Service Note		
Product	Description:	Service note no.
BM5 MKIII and BMCompact MKIII	Ground Loop Noise	SNo-T204

Due to a ground loop, these speakers may create a feeble noise.

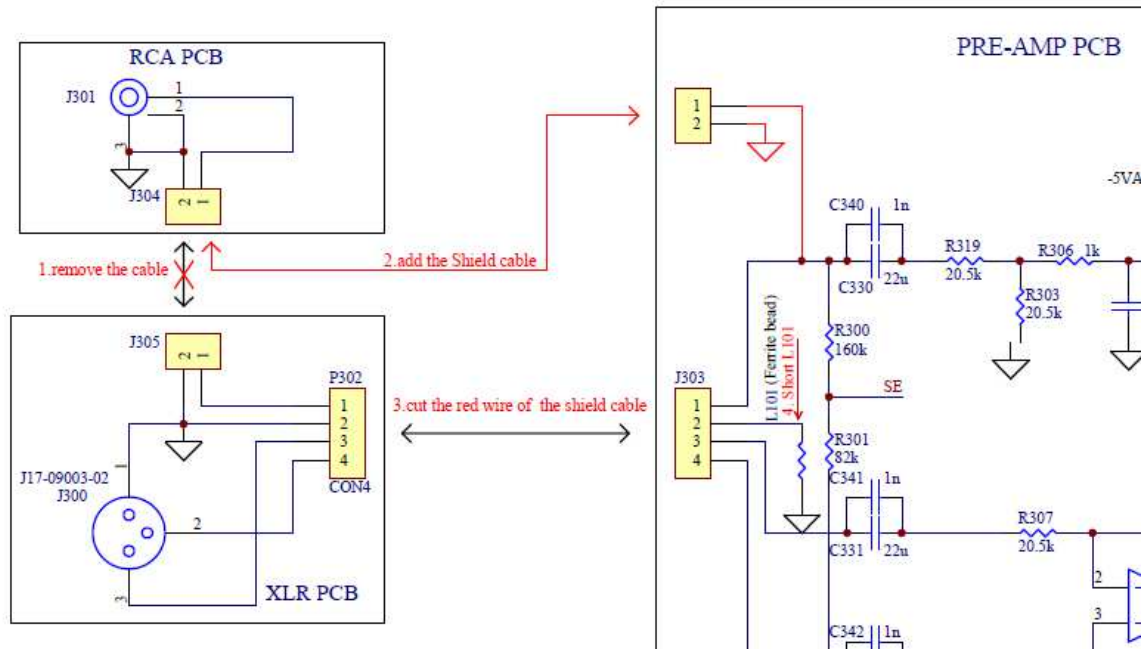
To eliminate the noise, the following changes can be applied. We will refer to the below numbers on the following pages in this instruction

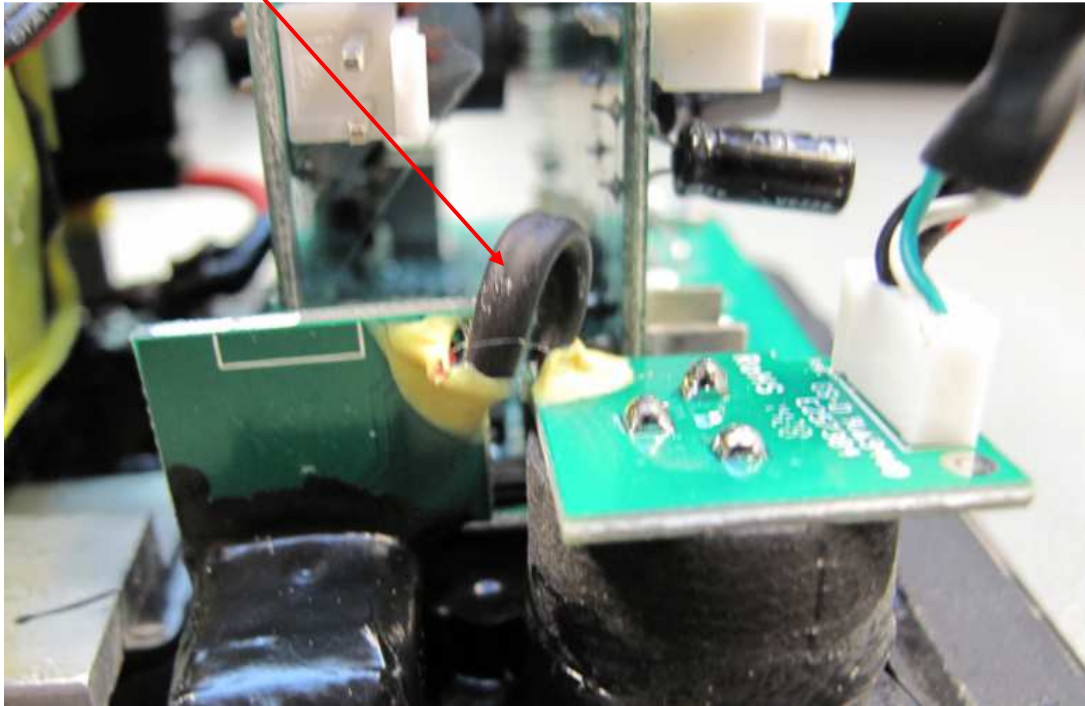
1: Remove the cable between RCA PCB and XLR PCB.

Prepare a 10 cm shielded cable like this (there are no closer specifications to meet):

2a: Solder on RCA PCB

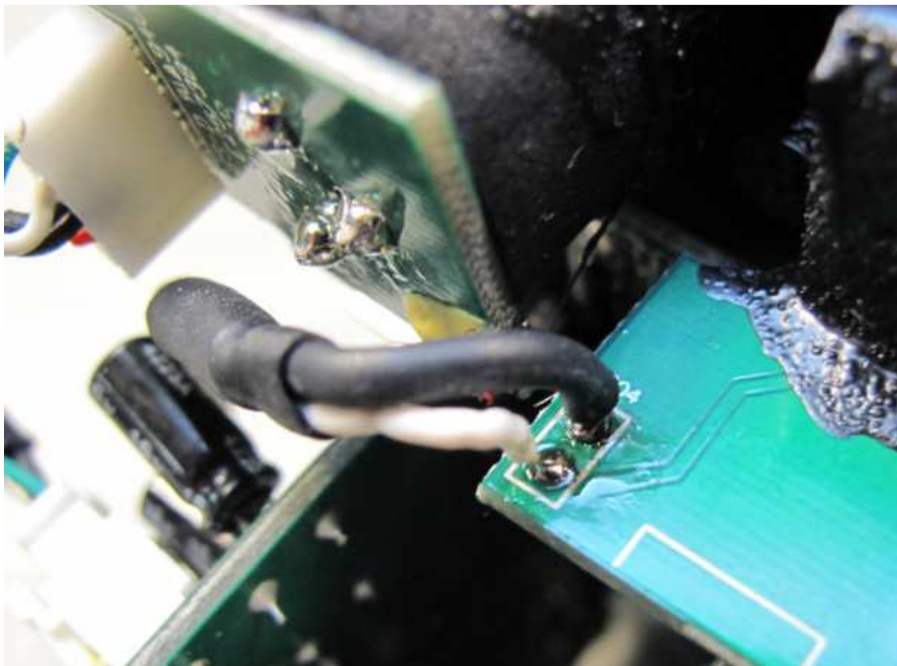
2: Add the shielded cable from RCA PCB to PRE-AMP PCB directly. See also next pictures.
